## NOTICE TO THE PUBLIC

GLO Grant, Contract Number: 22-082-001-D196
Eastland County, Texas

THIS NOTICE IS TO INFORM THE CITIZENS OF EASTLAND COUNTY THAT THE LOCATION OF A FEDERALLY FUNDED PROJECT HAVE CHANGED. EASTLAND COUNTY HAS RECEIVED AN INFRASTRUCTURE GRANT FUNDED THROUGH HUD AND THE TEXAS GENERAL LAND OFFICE FOR FLOOD AND DRAINAGE FACILITIES IMPROVEMENTS.

- Lake Leon Dam Safety Improvements, Auxiliary Spillway Erosion Cutoff Wall
   From approximately 1,500 feet north of the Lake Leon Dam on Ranch Road 2461, northwest approximately 1,400 feet (32.368080, -98.676601).
  - Original Length: 1,400 LF

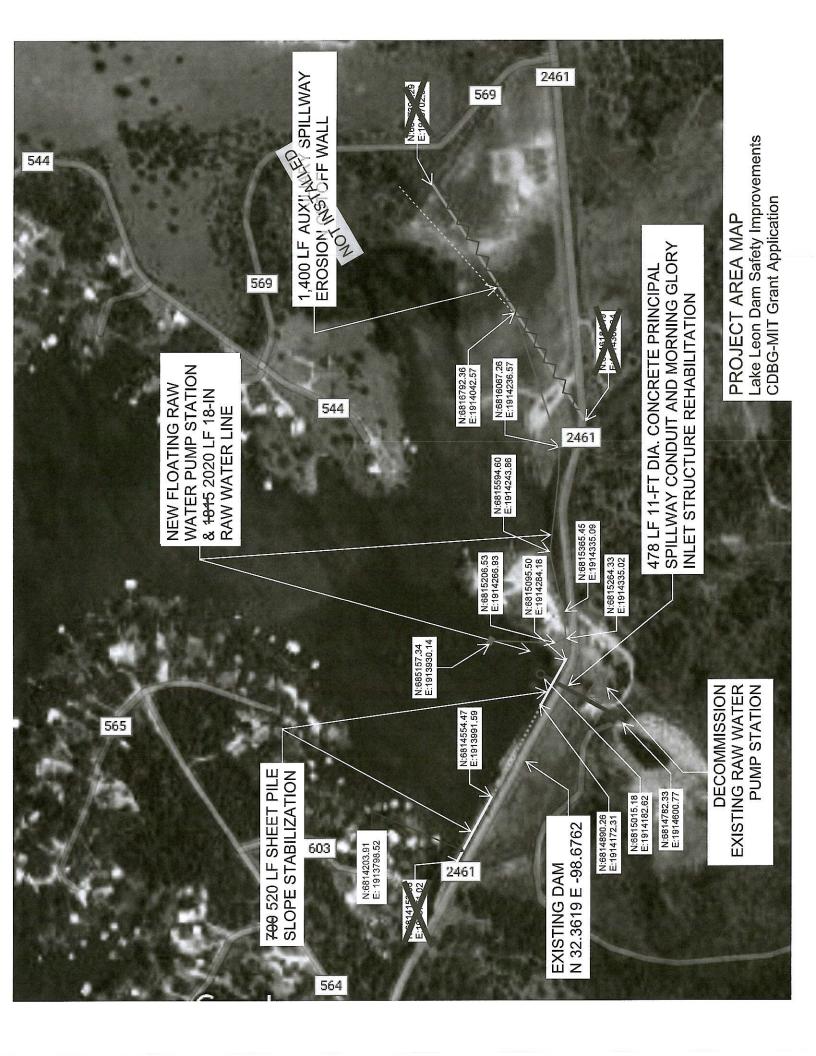
During the construction and final design phases, it became apparent that increased construction costs necessitated a reduction in scope to align with actual pricing. Cost estimates for the new floating intake came in at nearly double the original estimate, requiring adjustments to the dam safety improvements. The cutoff wall across the auxiliary spillway was removed from the project as it addressed risks present only under flood-loading conditions. Meanwhile, the remaining dam safety improvements prioritized addressing risks under normal reservoir levels—a more frequent loading condition.
